Docket Item # 6 BAR CASE # 2009-0212

BAR Meeting October 7, 2009

ISSUE:	Alterations
APPLICANT:	Alexandria Commission for the Arts and Alexandria Sculpture Festival
LOCATION:	1200A King Street
ZONE:	KR / King Street Retail

The applicant is requesting re-approval of previously approved plans for a Certificate of Appropriateness for the new base of the Sacandaga Totem sculpture and associated lighting. The sculpture will be located in the plaza area formed at the intersection of South Fayette Street, King Street, and Commerce Street.

Figure 3. Proposed site plan.

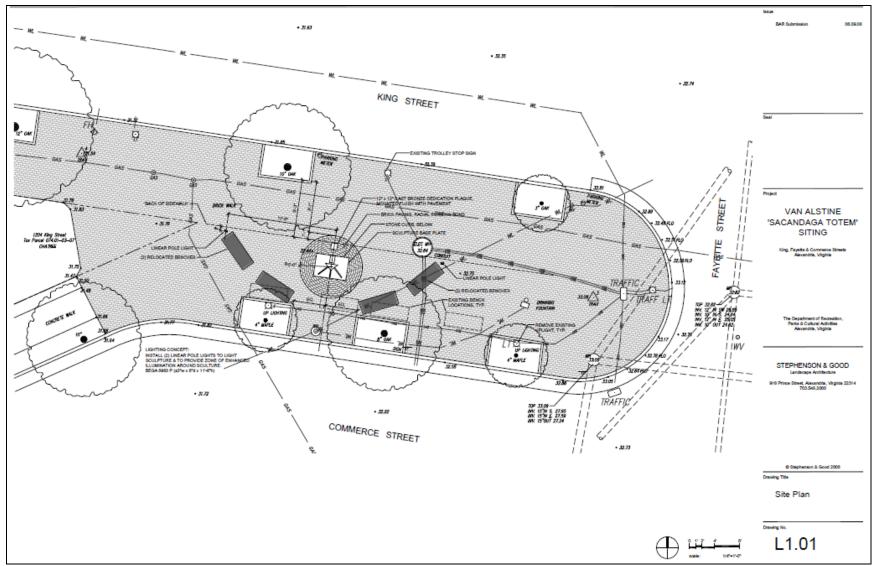
In Staff's opinion, the proposed base and lighting are appropriate in this context and for this use. Prior to the initial submission, the applicant worked with Staff to develop a base design that was minimal, yet compatible with the existing design of the plaza. The radial design provides a paving focal point for the sculpture within the plaza, without being too distracting or competing with the existing paving. The base itself is minimal in height and design, and allows the sculpture itself to be the dominant element in the plaza.

Figure 4. Site lighting plan.

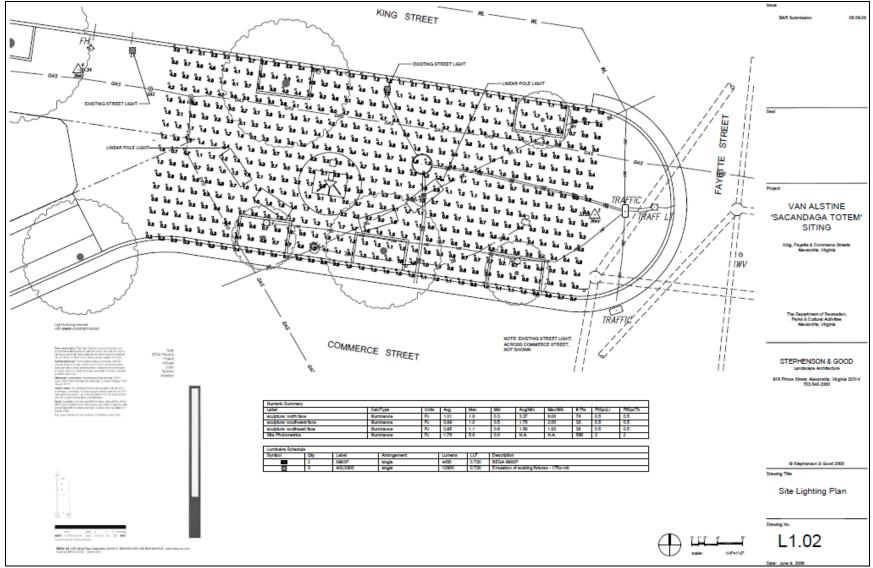
Two new linear pole lights are proposed to be installed in the plaza area, to illuminate the sculpture and provide lighting enhancement to the plaza area. The light poles will be installed towards the center of the plaza, at the ends of the proposed location of the benches. The light poles are manufactured by BEGA, in black aluminum, with a clear aluminum section housing the lighting element. The poles are each 12' in height. A site rendering showing the proposed poles was submitted by the applicant, as well as a photometric study.

The proposed lighting poles are appropriately "background" elements and do not detract from the more traditional street lamps currently in the plaza. The lighting levels are minimal to provide some nighttime illumination to the totem sculpture.

Figure 5. Sculpture base details.

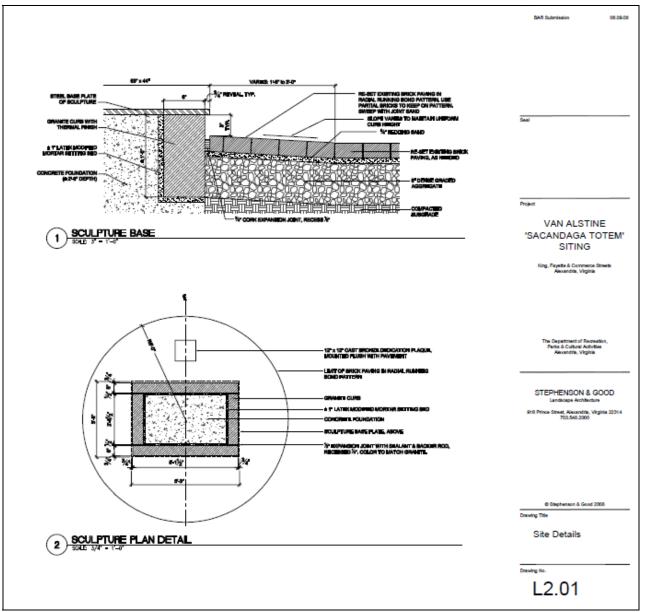
- Reduction of the thickness of the granite base curbing to six inches (original proposal was 12 inches);
- Change in specification of granite to "Virginia Mist" with a thermal finish, consistent with granite curbs in the historic district.

The proposed base for the sculpture consists of brick paving, in a radial running bond, with a rectangular base plate on which the sculpture will rest. The rectangular steel base plate will be installed on a concrete foundation surrounded by a granite curb approximately 3" taller than the brick paving. Despite the reduction in the thickness of the granite, the exposure of the granite base above the brick paving will remain the same as originally proposed. The steel plate will project about <sup>3</sup>/<sub>4</sub>" over the granite curb. The dimensions of the base will be 5'3" x 3'8". A 12" x 12" cast bronze dedication plaque will be mounted flush with the radial brick pattern pavement, in the northern arc of the brick pattern.
